# Rose Hill Mixed-Use

DRV18-00493

**Design Response Conference**  
Submittal #1R - DRV18-00493  
September 5, 2018

## CONCEPTUAL DESIGN CONFERENCE SUMMARY & COMMENTS

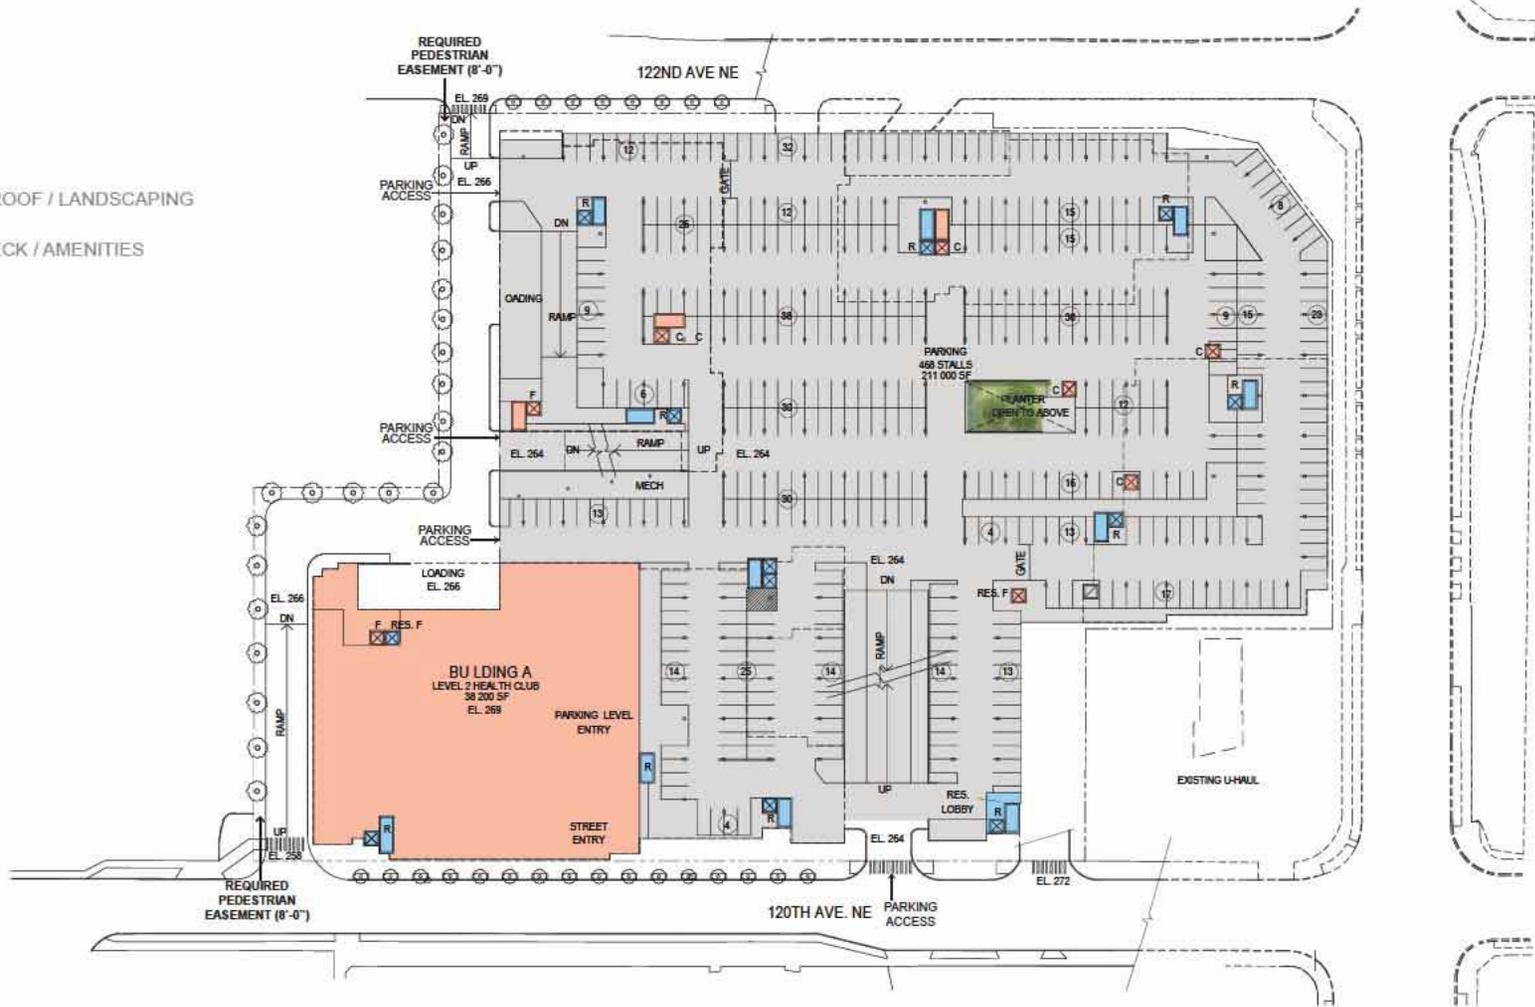
In general, the board appreciated the overall massing of the buildings. They would like to see further development of the north side and facade along 85th. They also encourage further development of the hub scheme design. The size of the hub scheme's open space seemed about right.

1 - DRB: Concern for the north facade and the height of the structure when viewed from the neighborhood to the north.	RESPONSE: The massing along the north side of the project has been carefully considered to no impose upon the adjacent properties. The building facades have been held back from the north property line approximate 45' to provide perimeter auto and pedestrian circulation and landscape buffering which minimizes the impact of the proposed buildings via landscaping and distance. In addition, the north building facades of building A and B have upper level step-backs, are broken into two separate buildings and provide generous modulation.
2 - DRB: Thinks the interior could be simplified with a diagonal piazza or simpler shape at the interior.	RESPONSE: Previous DRB deliberations favored the size of the Hub Scheme while preferring the well defined, strong form of the Piazza Scheme. Our proposed plaza configuration is a well-defined rectangular space that has been divided into distinctive automobile and pedestrian plazas. The space is well organized and easily comprehended which aids in clear circulation with a central focus.

3- DRB: Food services from the grocery store could engage 85th, ensure activation happens along 85th.	RESPONSE: Activation of the SE corner terraces and entrance stairs is very important to the success of the pedestrian access to the intersection. The grocery mezzanine will likely include a food service dining area, is positioned to spill out onto one of these mid-level terraces. The 85th street frontage will be well engaged via a continuous clerestory storefront which looks down into the grocery store. The east end of this frontage will provide a commercial space and a residential entrance/ lobby which is well-connected to the SE corner plaza.
4 - DRB: The abruptness of the approach to U-Haul, may also be an issue. We want to make sure that we don't end up with a very abrupt wall here, which is along 85th.	RESPONSE: Any previous abruptness between the building mass along 85th st. Relative to the U-Haul site, has been mediated by bifurcating our south facade into two buildings. In addition, the west elevation adjacent to u-haul of our residential massing has been held back from the property line and broken into two distinct building masses. This variation in facade design and orientation helps provide visual interest adjacent to the U-Haul Property.

5- DRB: Would like to see how the long walls will be modulated and/or broken up along 120th and 122nd.	RESPONSE: The previous scheme's long walls along the east and west elevations have been broken into more equal lengths, as well as been well modulated into distinctive facade types.
6- DRB: How will pedestrians like kids travel through the site? t's clear that the east is friendlier then west.	RESPONSE: Pedestrians well access and travel through the site via well defined access points. The southeast corner plaza will invite the visitors with a generous and well organized sequence of terraces connected via a grand stair. Entrance drives with generous sidewalks and landscaping will connect both 120th and 122nd Street's to the interior plaza. The need for any exterior circulation between the northwest in northeast side corners isn't relevant to off-site or on site circulation.
7 - DRB: The dilemma is that the project faces inward. I'm going to encourage the applicant to also face outward along 120th & 85th, in the same way that happens along 122nd.	RESPONSE: The previous scheme fronted parking garages along both 120th and 122nd. This exposed parking garage layout has been eliminated. The 122nd street elevation now provides street level commercial to residential entrance lobby's, with some residential units buffered by landscaping. The 120th street elevation now provides street level health club storefronts and residential entrances. Both 120th and 1202nd now provide pedestrian oriented frontages which provide an interesting and active walk and experience.

8 - DRB: I'm not sure that the Costco is a destination, or that the pedestrian pathway needs to extend all the way to the north. Signalization will be required at some point in the future.	RESPONSE: The existing pedestrian crosswalk will likely need to be relocated to provide direct access from the Costco store to the remaining Costco parking opposite 120th st. Whether signalization is necessary is yet to be determined.
9 - DRB: Residential uses at the ground floor should be encouraged along the sidewalks at both 120th & 122nd. Would like to see ground floor connections with section or elevations.	RESPONSE: Please see previous response regarding project facing outwards towards 120th and 122nd streets.
10 - DRB: Would like to see some of the clarity of the strong interior piazza form brought into the hub scheme, through the use of paving, landscape material, and edges of buildings.	RESPONSE: The strength of the previous interior piazza scheme was in the clarity of it's geometric space. Unfortunately, the development of the parking and pedestrian areas appeared very suburban and reminiscent of the strip retail center. Comparatively, we have reduce the size of the plaza, defined distinctive automobile versus pedestrian areas, and suggest clearly defined circulation patterns and casual seating areas, separated by generous landscaping. Please see the illustrated site plan.

11 - DRB: Definition of the outdoor room configuration is important. Sun exposure is important to preserve along the north edge of the grocery store, and the massing of the housing above.	RESPONSE: The central plaza is well defined by the adjacent commercial spaces, with the pedestrian implies a space appropriately scaled to appear well utilized and active. The upper residential facades are stepped back from the commercial massing to provide a secondary upper plaza scale which affords generous sunlight. The upper residential mass along 85th ST is divided to provide excellent midday sun exposure. The pedestrian plaza as well as the north grocery frontage will be an excellent outdoor experience.
